Design Review Board Staff Report

SUBJECT: DR14-26, BRAKES PLUS

DR14-26, Brakes Plus: site plan, landscape plan, grading and drainage, elevations, lighting, colors and materials for approximately 0.87 acres located north of the northwest corner of Higley Road and Chandler Heights Road zoned Neighborhood Commercial (NC) with a Planned Area Development (PAD) overlay.

ELEVATIONS

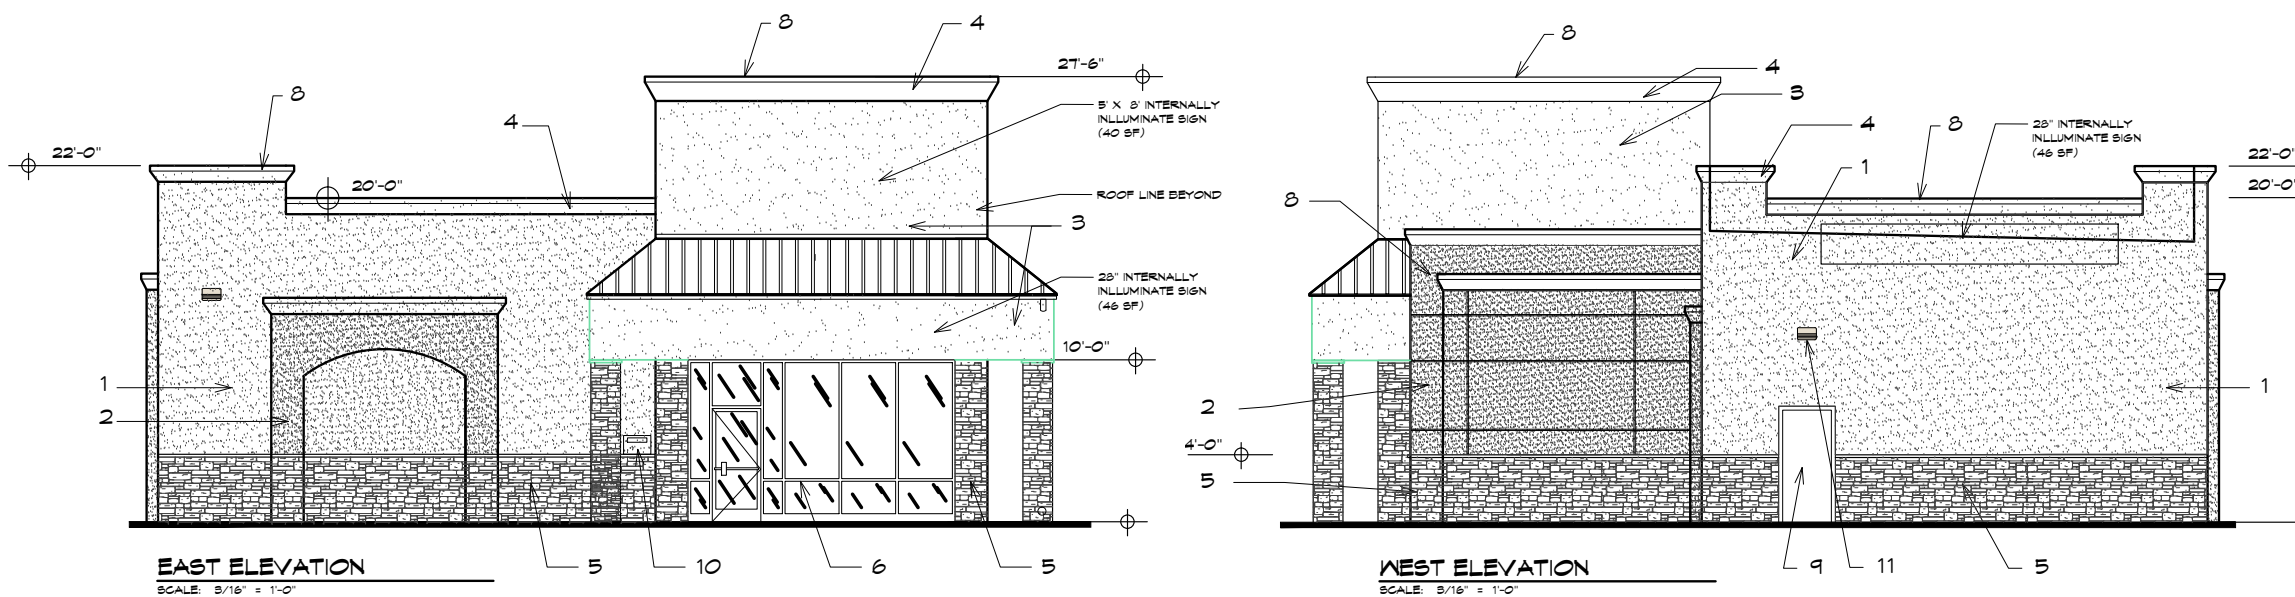
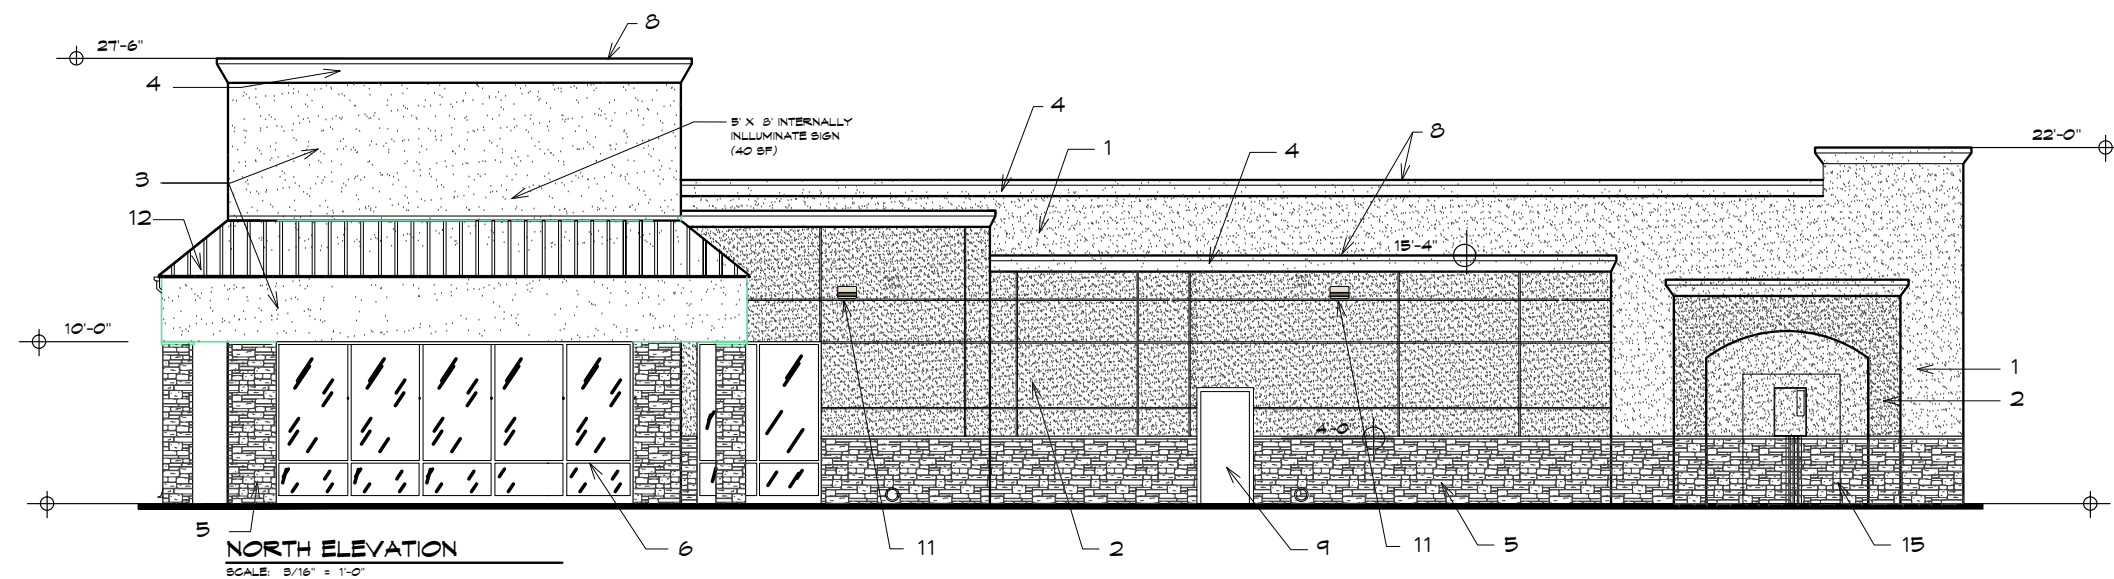
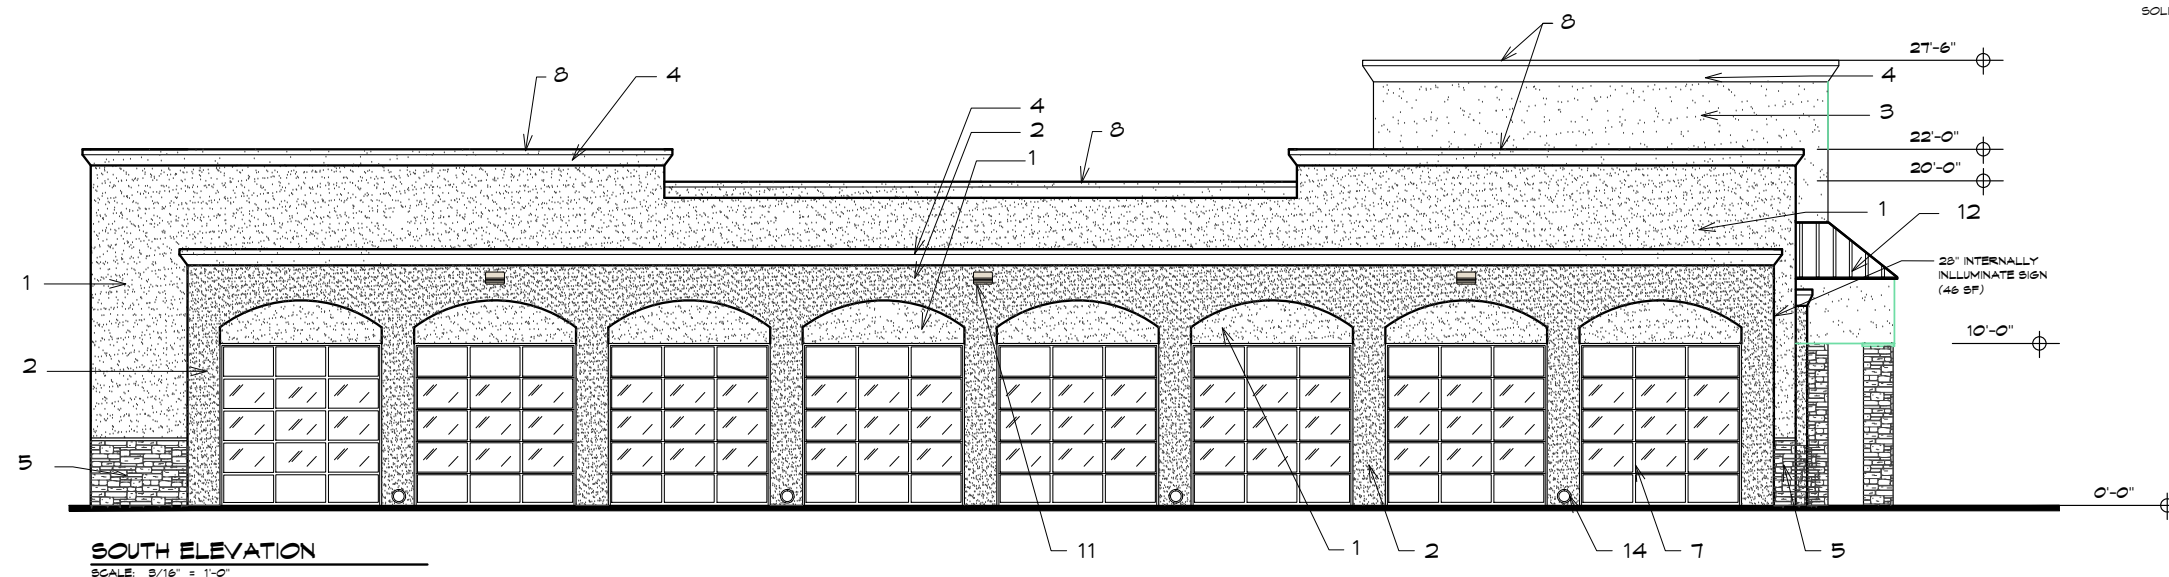
This request was first reviewed by the Design Review Board at the Board's September 11, 2014 meeting. During the public hearing, the Board made several suggestions for improving the proposed elevations, generally summarized as noted:

- Internalize external spouts
- Show proper relief for the service bay elevation
- Provide additional shade elements
- Provide more horizontal articulation along the east, north and west elevations
- Soften the vertical massing of the east elevation
- Provide more interest along the east elevation
- Carry forward the arch enhancements from the south elevation

Comment: Board Member Truitt shared that he is not very pleased with the elevations, specifically his concerns about the east elevation looking like a blank wall. He expressed that none of the elevations are really much better.

Comment: Board Member Truitt said that he didn't see a lot of horizontal articulation in the design, specifically in the south and the east elevation, or much in the west elevation. After reviewing the design he stated that it did look like there was some articulation in the north elevation but he was concerned about the other elevations.

Comment: Board Member Palmer stated concerns regarding the south elevation and referenced the single plane. He suggested that maybe the darker color could pop out a foot. He pointed out the right side of that had a skinny column and the left side there was a thick column so he suggested that there was work that needs to be done in that area as well. He suggested offset planes there to help break up that long plane that's there. He also suggested that the east side could possibly add a window or something similar column and arches around it to dress that side up.

Comment: Board Member Alam expressed that he saw many different elements on the design but he didn't see the different elements coming through on all sides of the elevations. As an example, when an arch is used on one elevation, he wondered where the arch was on the other elevations. He suggested taking one element and expressing it on all four sides.

The applicant has revised the proposed elevations and site plan to address these comments. The east elevation has been modified substantially to provide more visual interest with an additional arch feature and to provide better visual symmetry by reducing the massing of the roof relative to the height of the building's pedestrian entryway; the entryway has also been enhanced by the placement of stone veneer columns to support the larger and more visually-dominant integrated canopy feature. The west elevation has been enhanced adequately with additional articulation and the relocation of the service entry. The northern elevation has been improved by carrying forward the arch design concept as well as wrapping the redesigned entry canopy feature. Additional vertical movement has also been created along the northern elevation. Along the southern elevation the downspouts have been internalized and the projection of the canopy bay wall has been more accurately depicted.

A-3.2

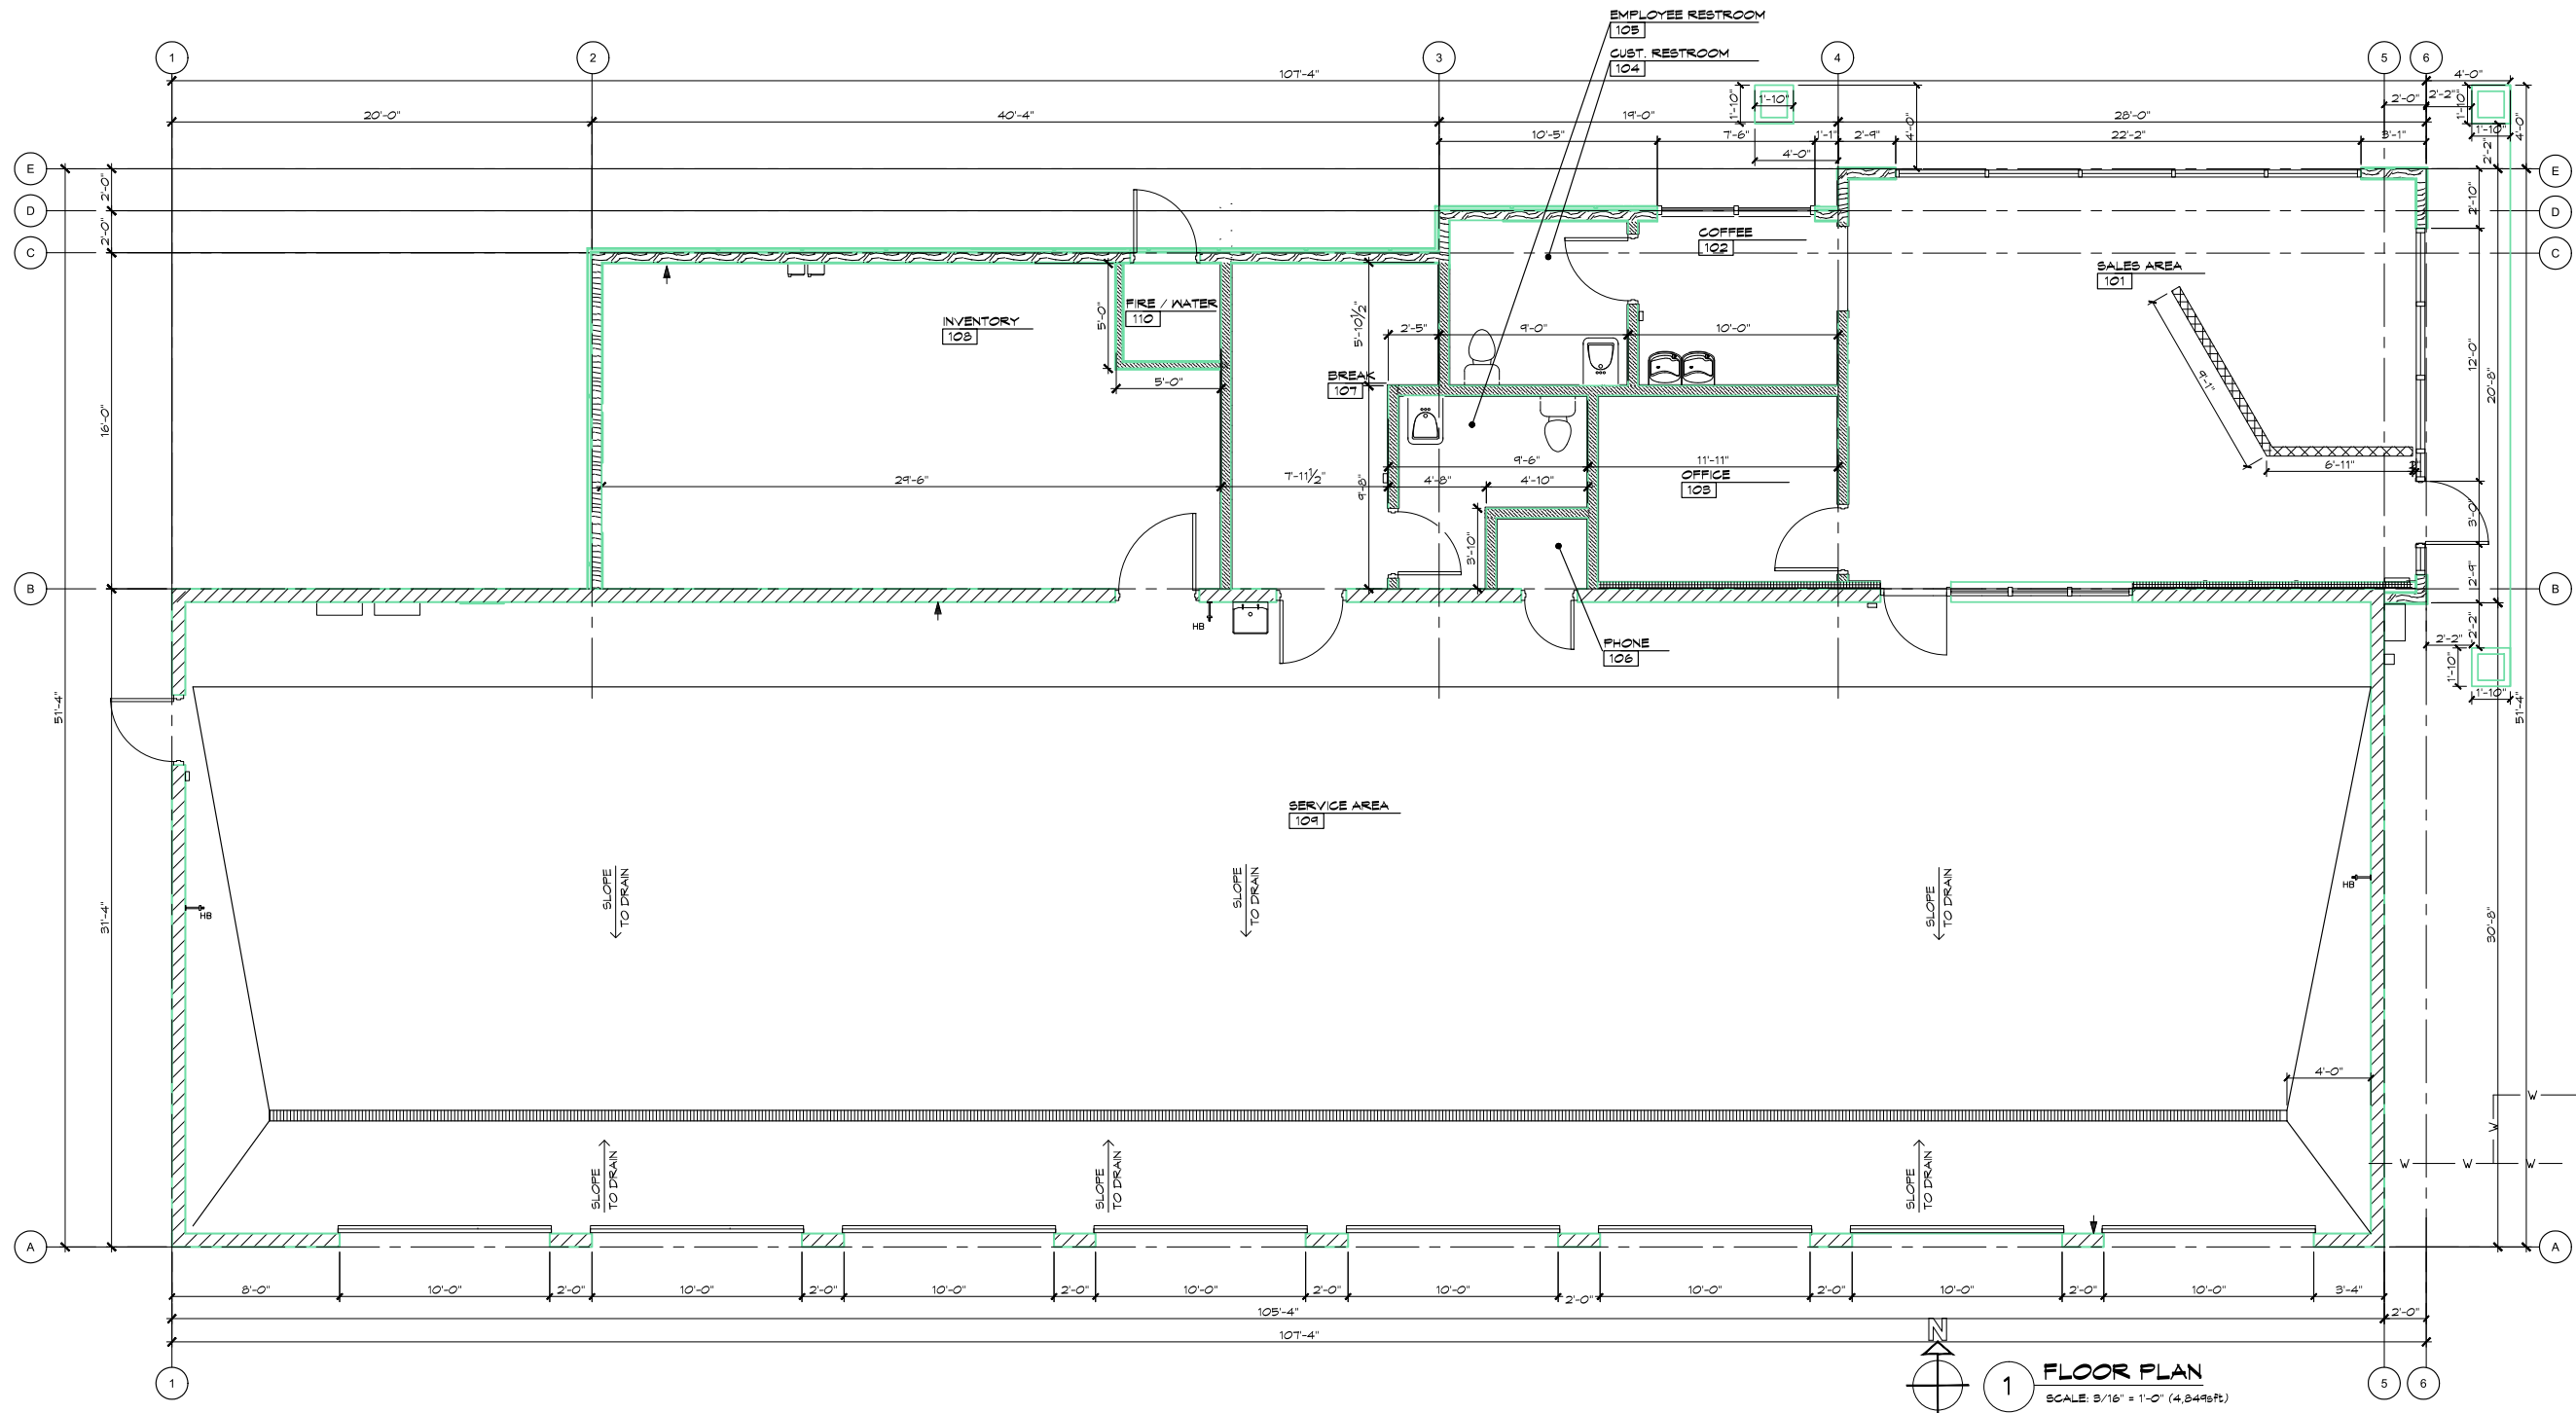
Question: Vice Chair Andersen asked about the south elevation.

Question: Vice Chair Andersen asked about an area on the elevation and whether it was recessed a foot.

Comment: Vice Chair Andersen stated that looking at the plans, they don’t indicate the recessed area. He would have an issue if that area was all one plane.

Response: Planner Feld shared that he thought the area in question would be recessed. He then pointed out that the applicant was in attendance and verified with applicant that it was. Applicant shared that there was a small architectural difference.

Response: Board Member Truitt shared that it was probably only an inch or two, not a foot.
